AGENDA

PLANNING AND ZONING COMMISSION WORK SESSION City Hall, 385 South Goliad, Rockwall, Texas Council Chambers May 28, 2019 6:00 P.M.

A101

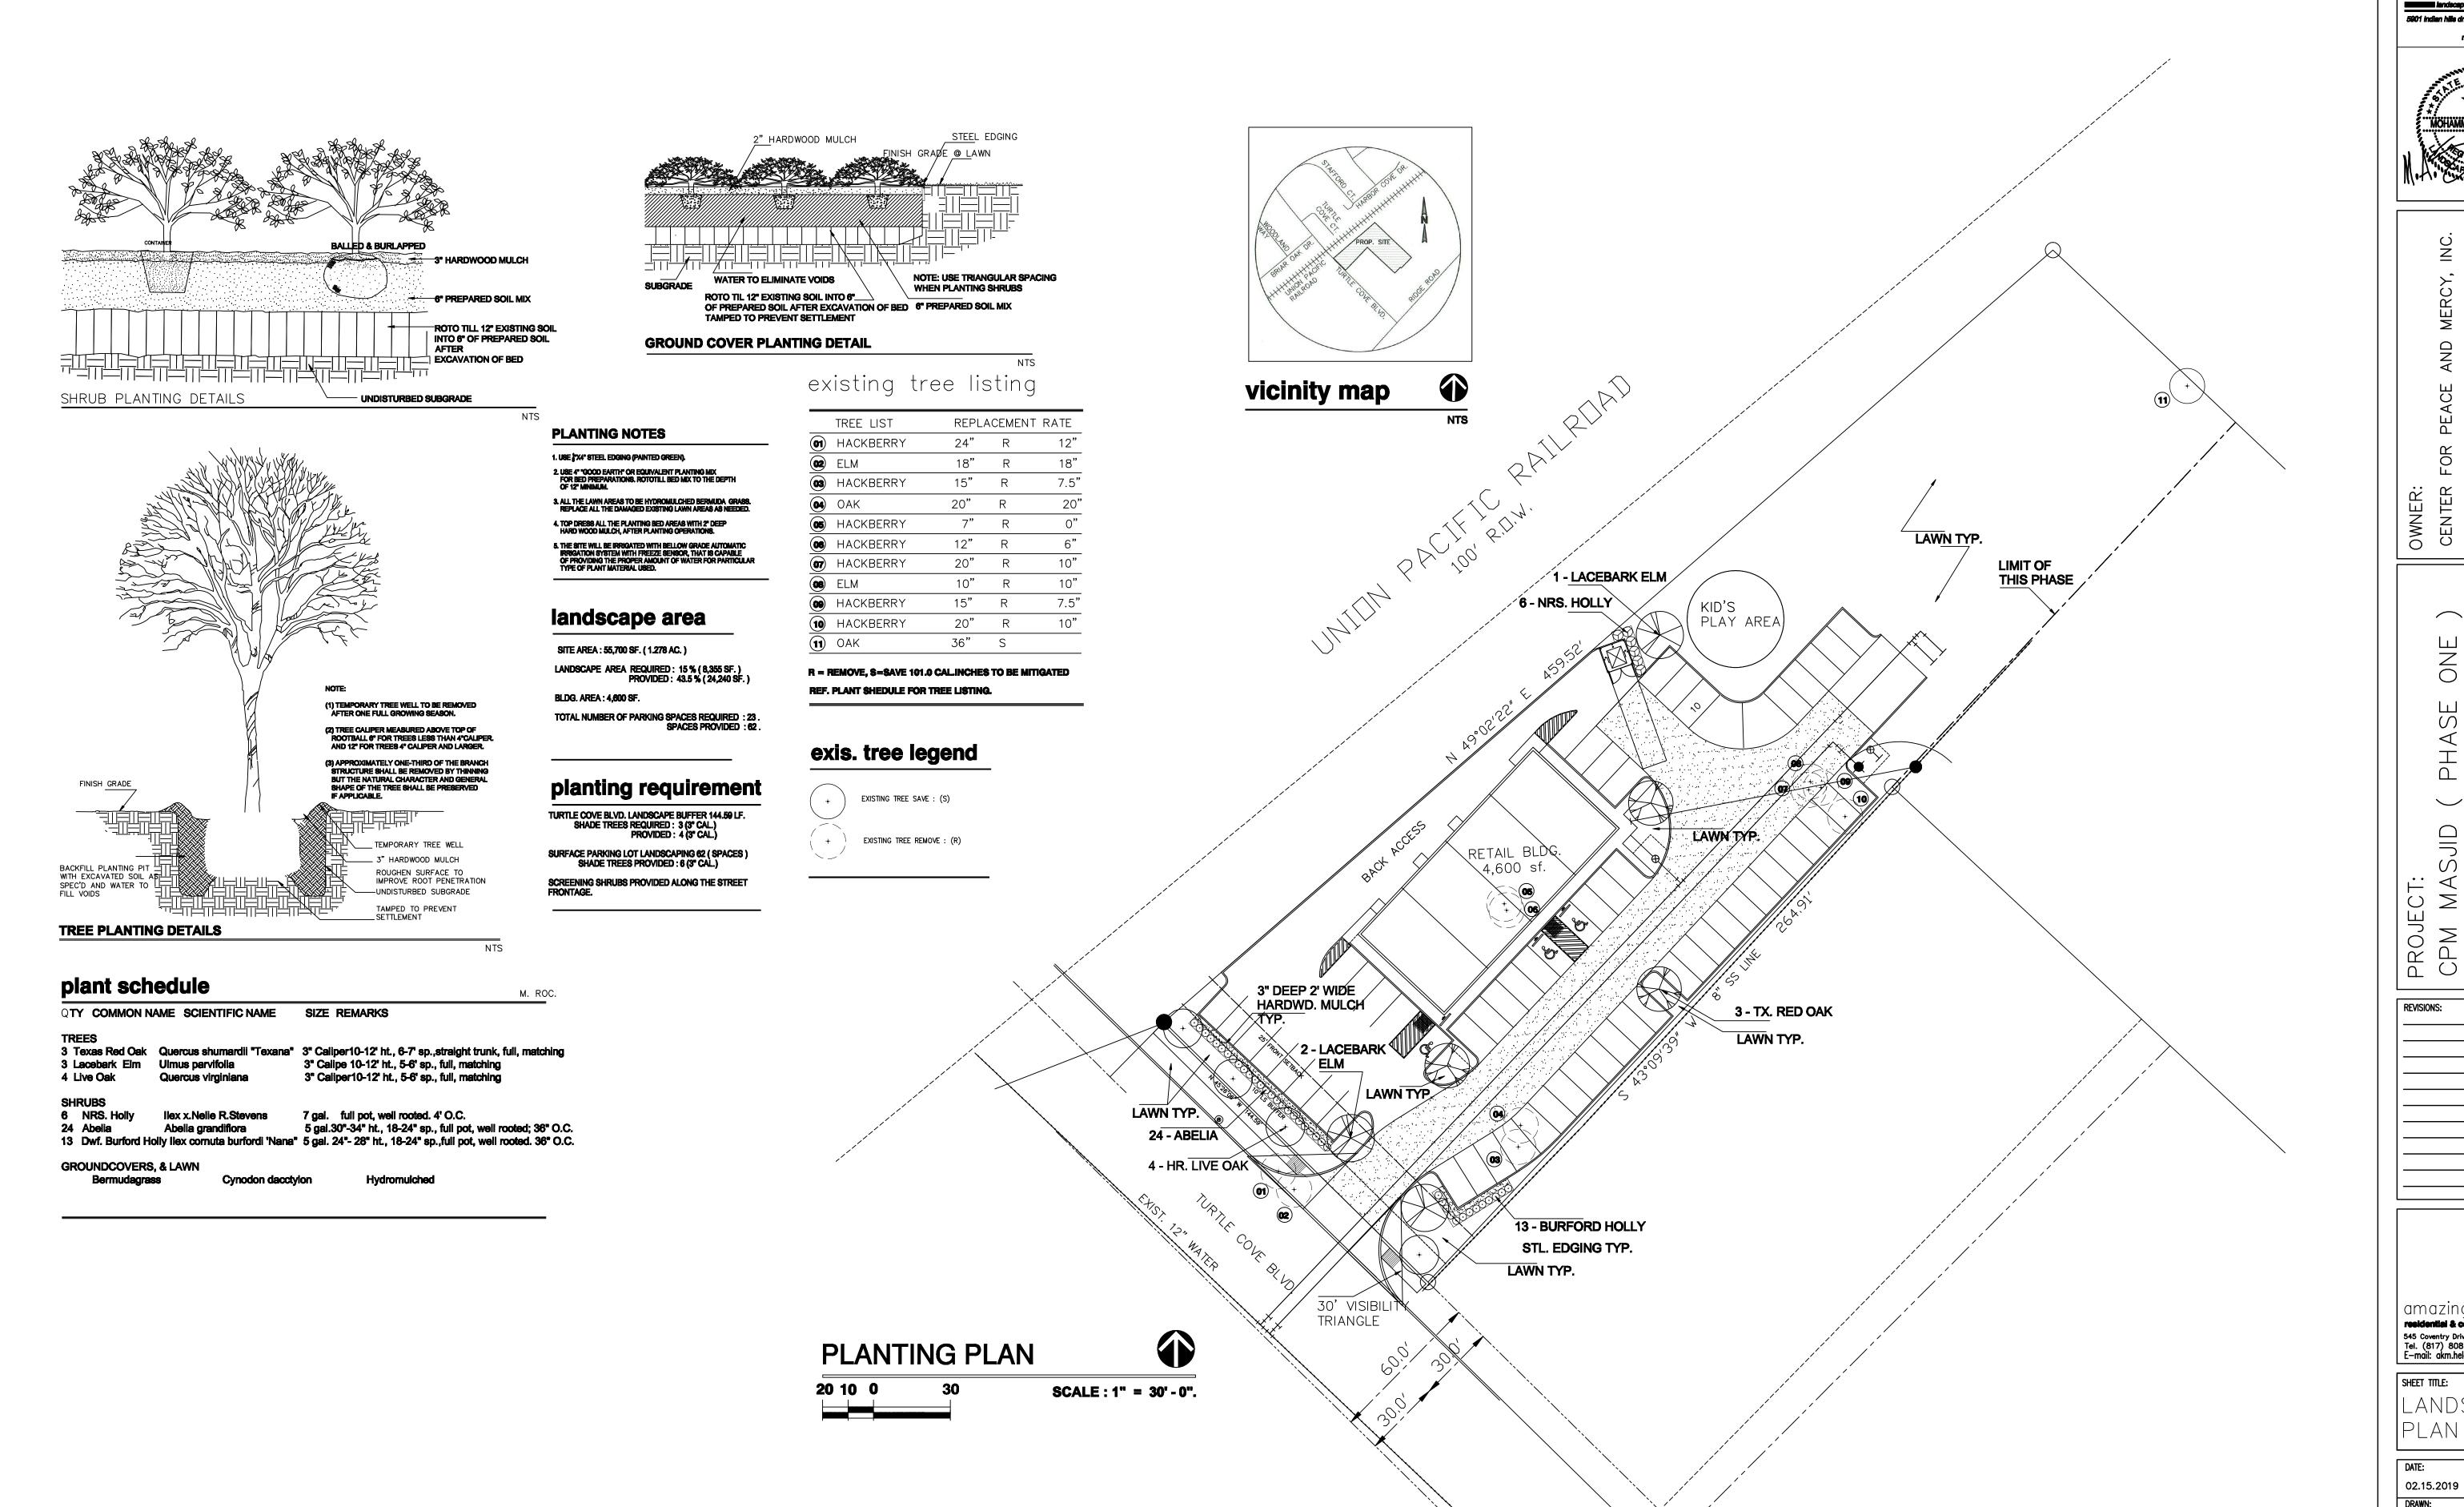
- 6. Sheet No. A101—This sheet doesn't seem to be necessary. The site plan on sheet C1 is the type of site plan that is needed. Please transfer site data table to remaining sheets.

- 7. Sheet C-1—Please note that in overlay district the dumpster screening is 8-feet, materials matching the main structure, with self-latching opaque gate.

- 8. Sheet C-1—There is a large amount of information on this sheet. Please greyscale topo and utilities.
- 9. Sheet C-1—Since there is large amount of lines on this page, could the firelane change from a hatch pattern to a solid grey? Show any remaining pavement, including sidewalks as a different shade of grey.

- 10. Sheet C-1—There is a reference to a "water easement by this plat" on the building footprint. Please remove along with any other plat references (e.g. the references to state plane coordinates). The plat will be taken care of at a later time.

- 11. Sheet C-1—Please use varying line weights and types to provide clearer differentiation. Also provide those changes in the legend. There are several items that use the same linetype.

- 12. Sheet C-1—Please show all proposed easements and extend of detention.
- 13. Sheet C-1—Please greyscale information on adjacent sites (i.e. any information that is not on your lots).

- 14. Sheet C-1—Please remove water meter schedule.
- 15. Sheet C-1—Please note that parking is 9x20.
- 16. Sheet C-1—Please revise access easements to "Public Access" instead of "Mutual"

- 17. Sheet C-1—Please remove symbols for IRF/similar
- 18. Sheet C-1—Please show division of worship area vs retail.
- 19. Sheet C-1—The parking close to the RR and Turtle Cove is dead end and will probably need a turnaround to allow vehicles to back out of the space.

- 20. Sheet C-1—No parking space shall be more than 80-feet from a canopy tree.
- 21. Sheet C-1—The site plan shows three or four thick grey lines that are not labeled. Some are adjacent to the property line and one is adjacent to Turtle Cove. What are these lines? Also there are several lines in the ROW that are not labeled. Please try to label all lines.

- 22. Sheet C-1—Will the two lots be combined?
- 23. Sheet C-1—What are the two pie shaped "parking spaces" near the play area? They cannot be parking spaces; however, I cannot determine what is being shown.

- 24. Sheet C-1—Please note that the landscape buffer is 20-feet and the building setback is 15-feet.
- 25. Sheet C-1—Please provide dimensions of all walls.

- 26. Sheet C-1—Please provide dimensions from building to all property lines.
- 27. Sheet C-1—Please note that the building does not meet horizontal articulation requirements as drawn and will need a variance. Please review Commercial articulation requirements.

SHEET TITLE:
LANDSCAPE
PLAN

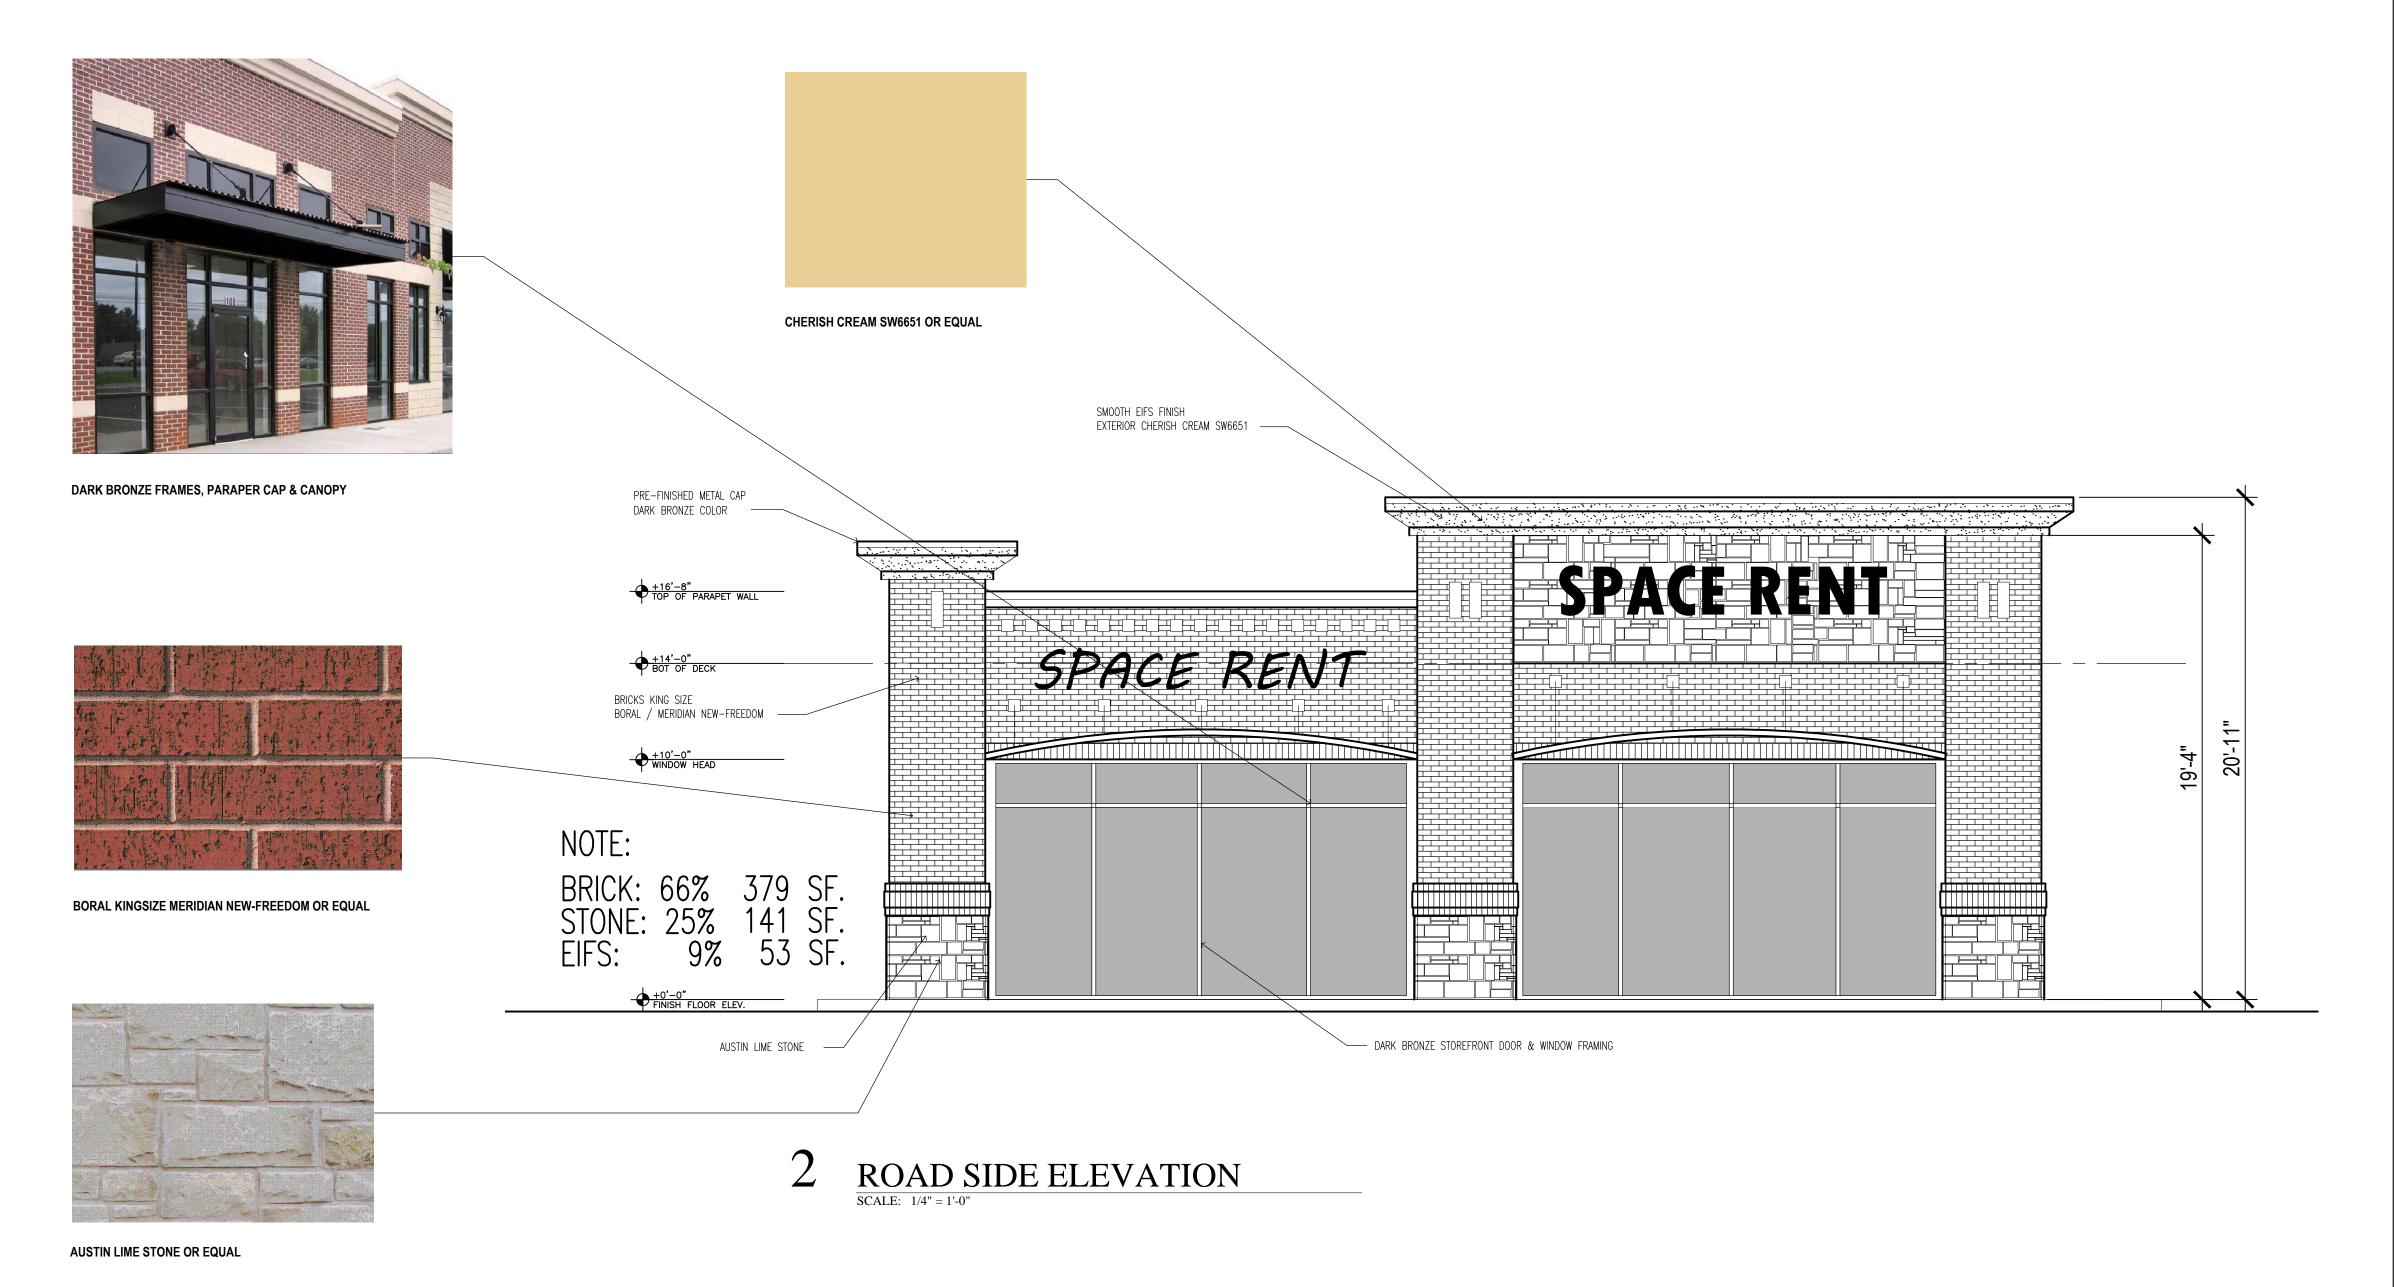
- 28. Sheet LP.01—please dimension a typical parking space—also as noted, parking must be 9x20.
- 29. Sheet LP.01—The parking and building can be greyscaled so that the landscape plan focuses on the landscaping.

- 30. Sheet LP.01—Please note that the landscape buffer is 20-feet and the building setback is 15-feet.
- 31. Sheet LP.01—Please provide the actual footprint of the building (i.e. show any projections or recesses).

- 32. Sheet LP.01—Please provide adjacent property information as shown on C-1.
- 33. Sheet LP.01—Please darken and label property line for subject property.

- 34. Sheet LP.01—There several dashlines toward the SE of the property that are not labeled. Please label all lines, provide a variety of lineweights/types. A legend can be provided in lieu of labeling each line. As drawn, the utilities and property lines, ROW, etc. have the same line weight and type.

- 35. Sheet LP.01—There are several dark circles with a line projecting and several open circles. Please label or provide a legend.
- 36. Sheet LP.01—As on Sheet C-1, please show firelane as a shade of grey and any remaining concrete as a lighter shade of grey. Please use the stippling pattern currently being used on the firelane to show where grass will be.

- 37. Sheet LP.01—Please add site data table as mentioned above. Some of the needed information is already being provided on the sheet; however, please replace with the same data table so that all sheets have the same data table/same information.

- 38. Sheet LP.01—Please darken visibility triangles
- 39. Sheet LP.01—What are the two hatched areas at the end of the parking toward the rear of the building?

- 40. Sheet LP.01—For consistency purposes, please change title from Planting Plan to "Landscape/Treescape Plan"
- 41. Sheet LP.01—Please note that the min caliper inch for trees is 4-inches.

- 42. Sheet LP.01—Please note that headlight screening may be required along the property line adjacent to the RR.
- 43. Sheet ESP—Please removed the details of the light pole. Just show the pole from the ground up and provide height.

EXTERIOR ELEVATIONS

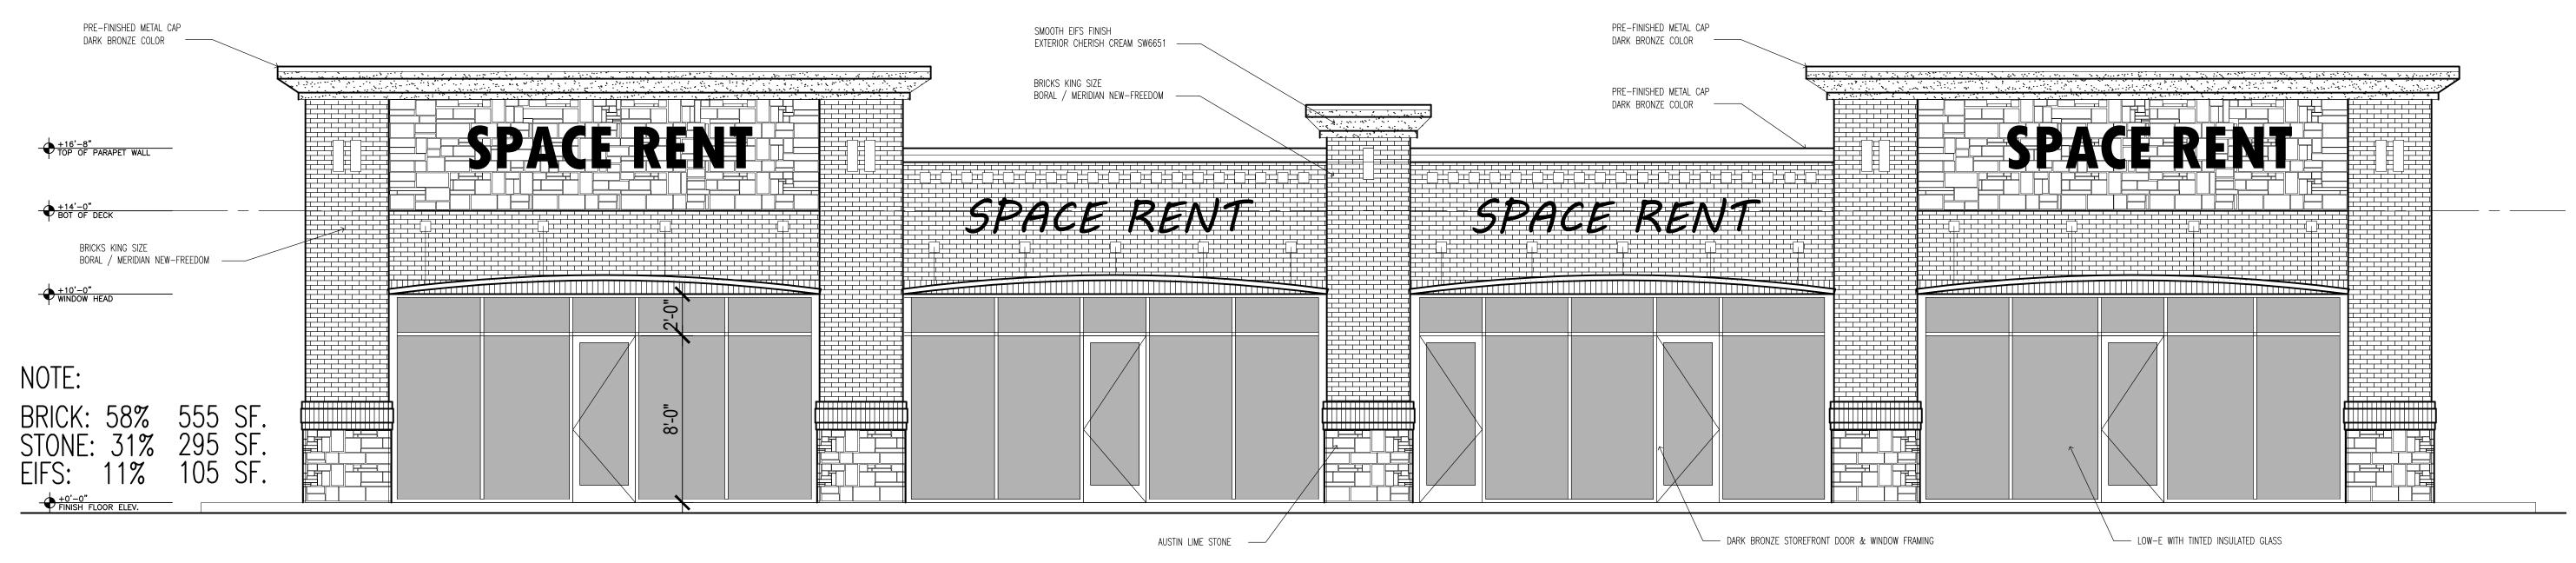
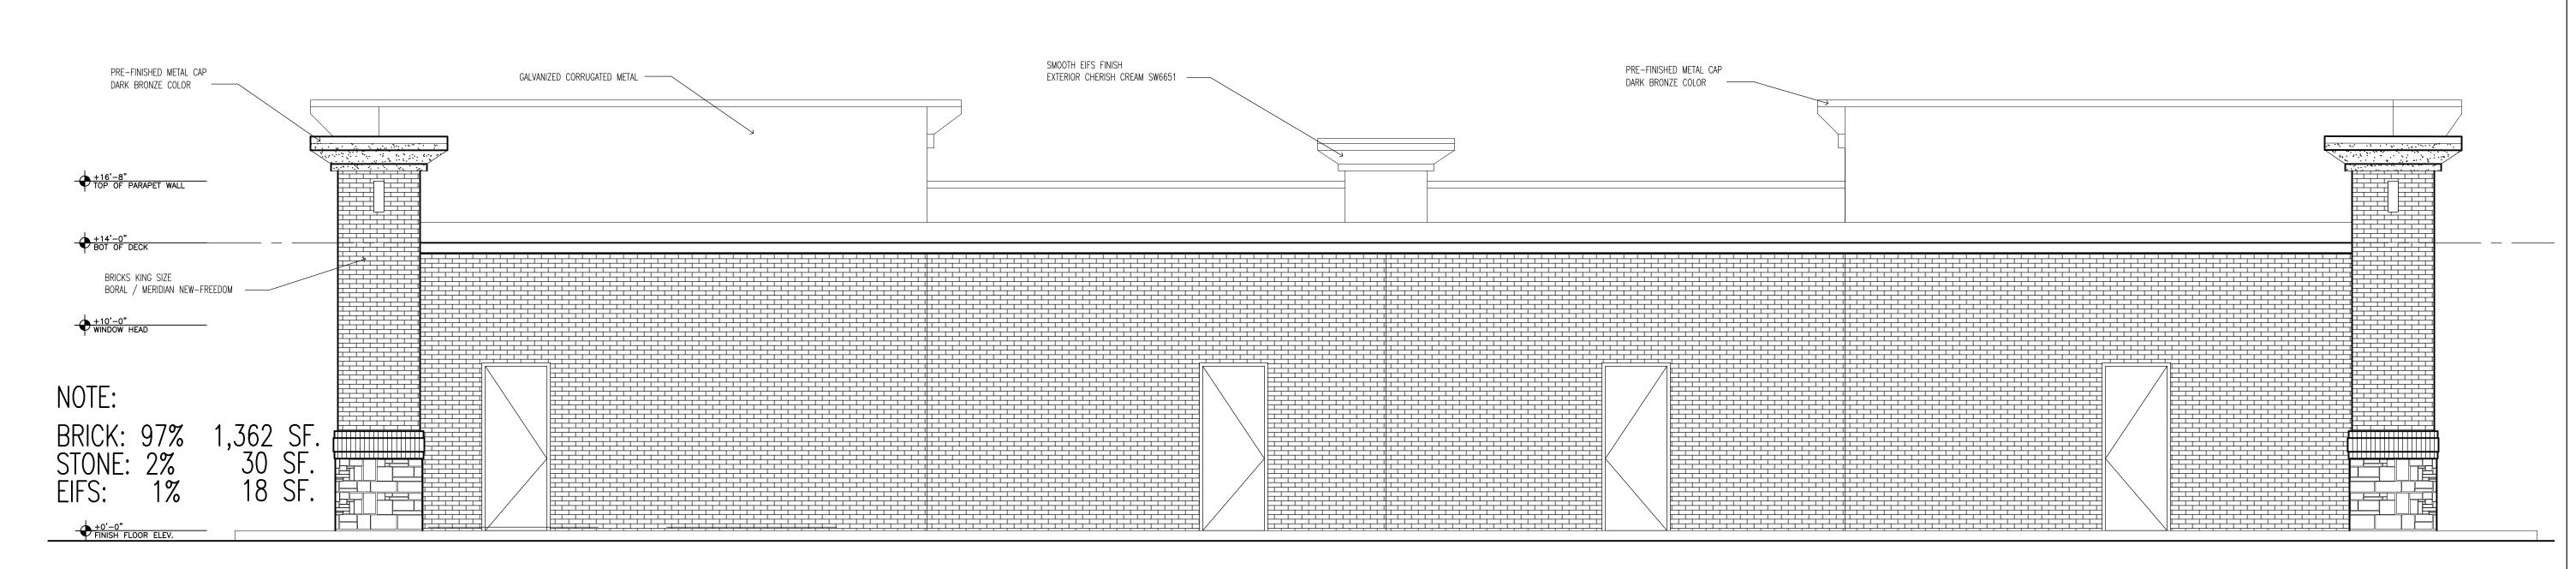
- 56. Sheet A501—Please remove all signage.
- 57. Sheet A501—Please add cardinal direction to all elevation.
- 58. Sheet A501—Please provide height of "tower element" closest to the building material percentage on elevation 2 and the element directly below on elevation 1.

- 59. Sheet A501—Please provide site data table.60. Sheet A501—Are the tower elements flush with the façade or do they project?
- 61. Sheet A501—Please note, as shown, the building elevations will require a variance to 4-sided architecture, and vertical and horizontal articulation.

- 62. Sheet A501—Please note that all buildings shall be architecturally finished on all 4 sides with the same elements and materials.
- 63. Sheet A501—Please note that elevation 1 exceeds the max of 10% EIFS—this will require a variance.

- 64. Sheet A501—Please label the material above the window as provide type of material for awnings.
- 65. Sheet A501—Please provide elevation of dumpster enclosure.

- 66. Sheet A501—Please dash-in all rooftop equipment and provide information on how it will be screened.
- 67. Please label at least one set of light fixtures on each of the elevations.

- 68. Sheet A501—What material is the small squares on the building elevations?
- 69. Sheet A501—is the stone a natural stone?
- 70. Sheet A502—Please note that the two elevations are labeled the same as the elevations on A501.
